HISTORIC AND DESIGN REVIEW COMMISSION

HDRC CASE NO: 2023-349
ADDRESS: 1231 S ALAMO ST
LEGAL DESCRIPTION: NCB 750 BLK 9 LOT 8 & SW 30 FT OF 7
ZONING: RM-4, H
CITY COUNCIL DIST.: 1
DISTRICT: King William Historic District
APPLICANT: Theresa Mauricio/New Day Custom Homes LLC
OWNER: Theresa Mauricio/New Day Custom Homes LLC
TYPE OF WORK: Construction of a 2-story addition and curb cut installation
APPLICATION RECEIVED: September 26, 2023
60-DAY REVIEW: November 25, 2023
CASE MANAGER: Rachel Rettaliata

The applicant is requesting a Certificate of Appropriateness for approval to:

1. Construct an approximately 1,076-square-foot, 2-story addition sited to the east side of the primary structure.
2. Install a new curb cut and driveway off S Alamo.

SITE PLAN LAYOUT

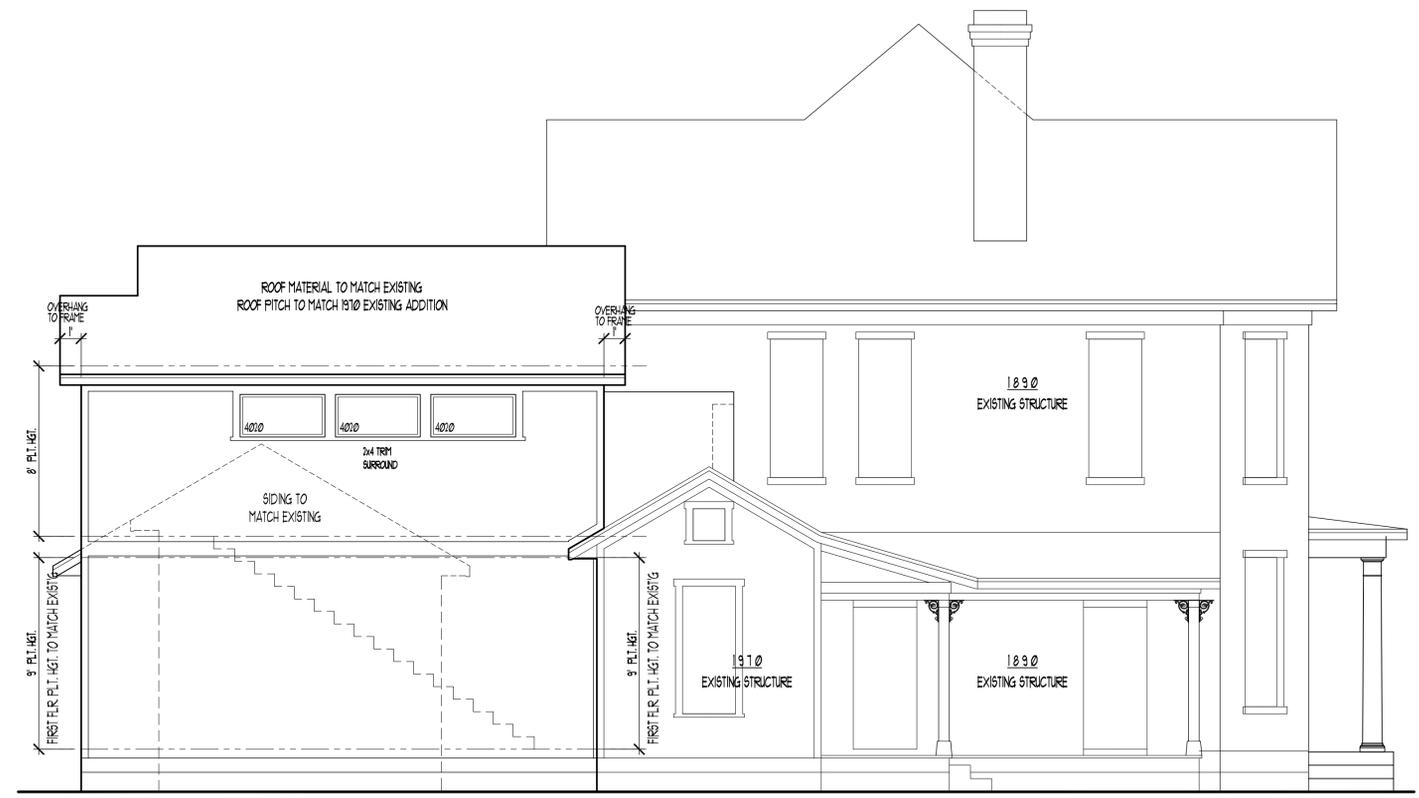
- i. That the applicant explores siting options that do not visually impact the front façade based on finding d. The applicant must submit updated site plans and elevation drawings to staff for review prior to returning to the HDRC.

Fetzer: I think what would bolster your argument is if on either the site plan or floor plan, show the wall of the 1890s house on your plans, show some overall dimensions of north walls of the 1890s house. If we had dimension from ne corner of historic house back to the new construction, which appears to be about 18' or so, if we had a dimension for that so that staff and commission could see that you're more than halfway back from the front façade with your bathroom extension.

FRONT ELEVATION

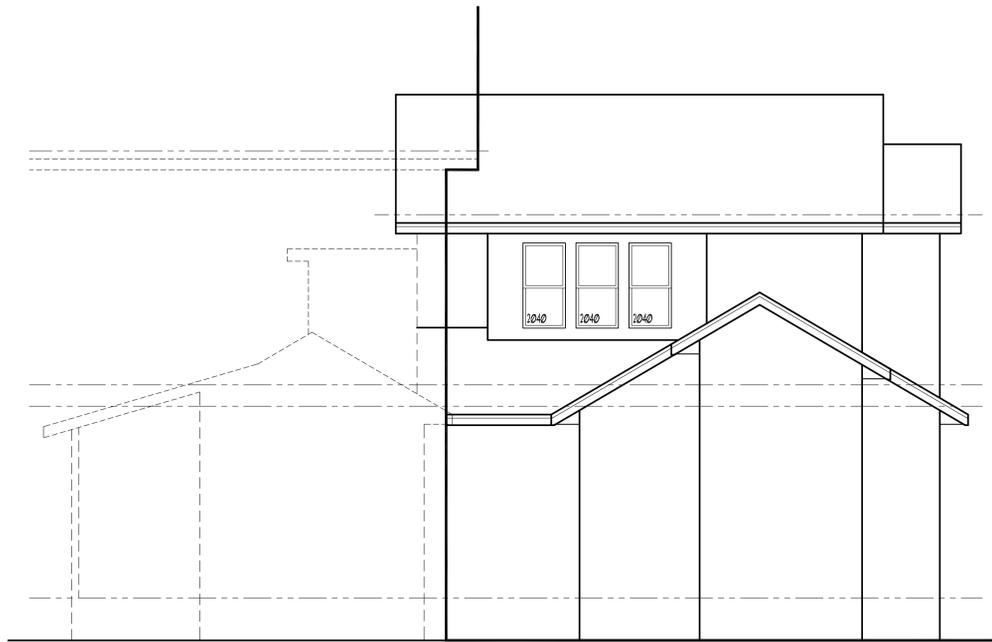
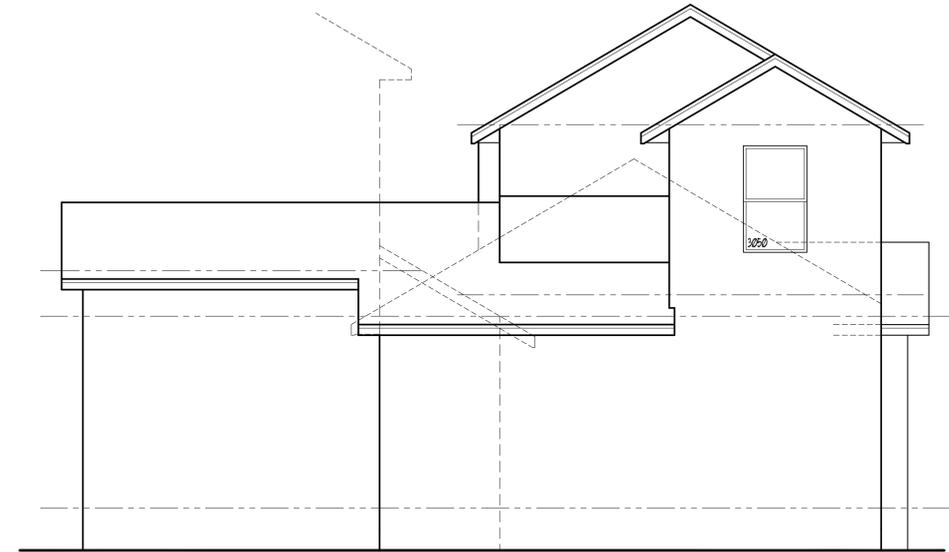
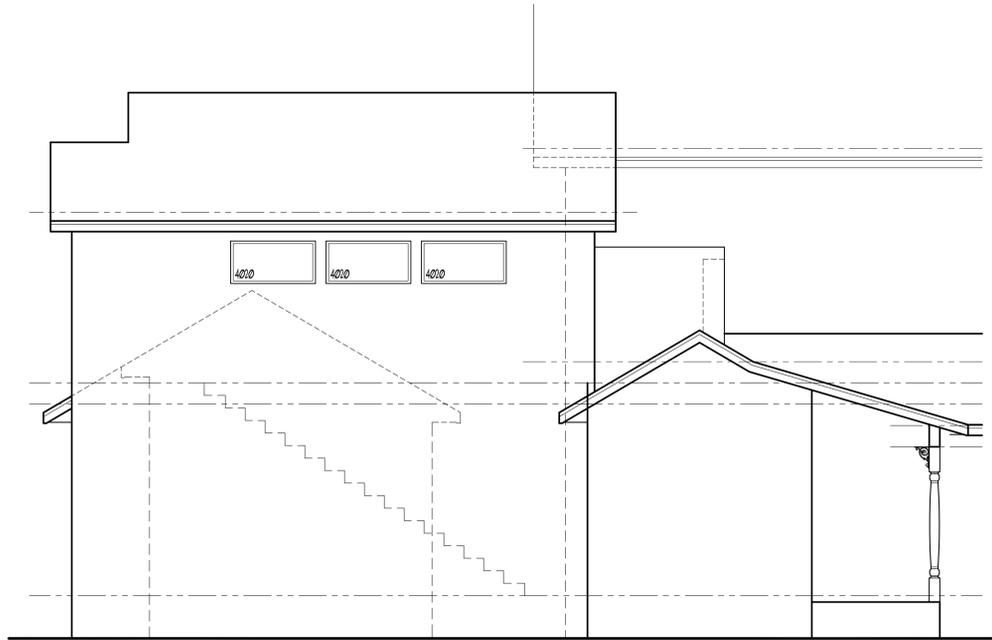
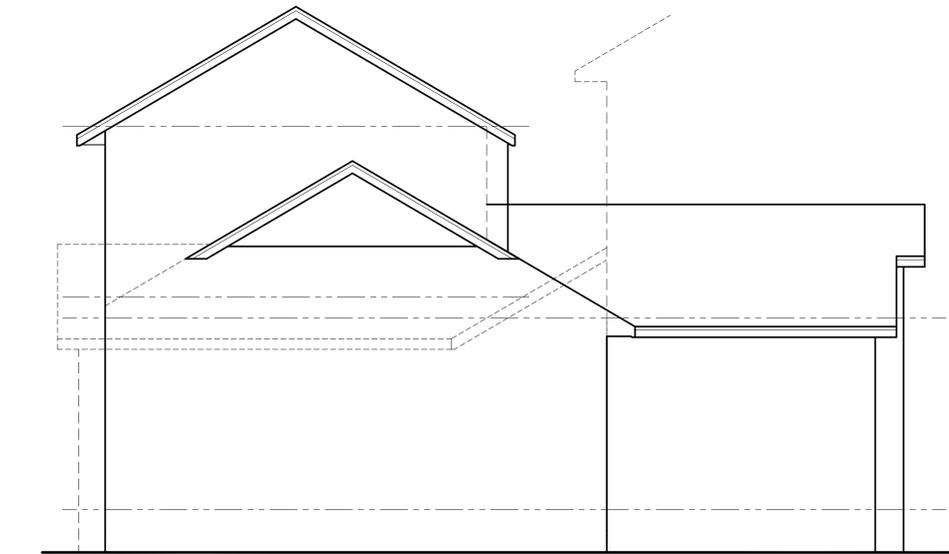
Fetzer: If you have photoshop or rendering capability, but if you had a photo off of google earth off the front of the house and then photoshop or draw in the proposed east façade of the addition, again, it would help show how far back you're proposing to set this.

Guevara: On rendering, add foliage we discussed to show final conditions.
